Access Compliance Report

Public Rights-of-Way (Curb Ramps)

Intersection ID: 52490	Main Street: WHITEHALL EXECUTIVE CENTER DR	Cross Street: PRAGUE LN	Location: S
ADA ID: 45078A1AABA7	Ramp Type: Perp	Initial Pass/Fail: Pass	Overall Compliance: No
Severity Score: 5			
Codes/Mitigation Info/Possible Solution		Field Measurements/Component Compliance

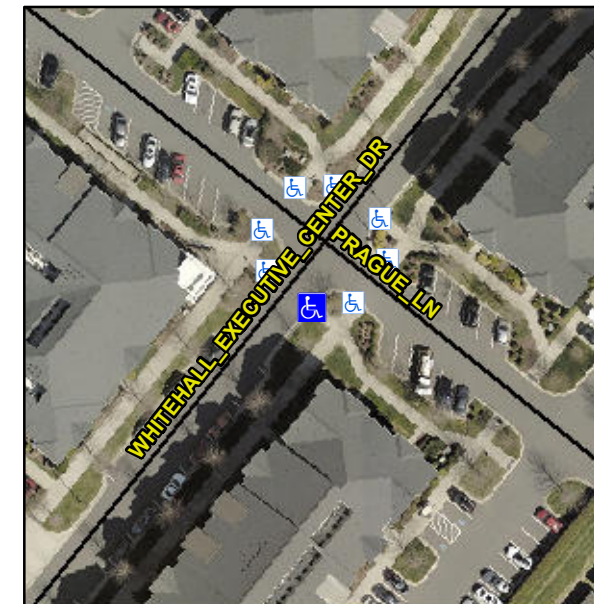
**Remove & Replace Entire Ramp.
Remove & Replace Gutter.**

**Not Found, R304.2.2-Perp, R304.3.2-
Para, R304.5.4**
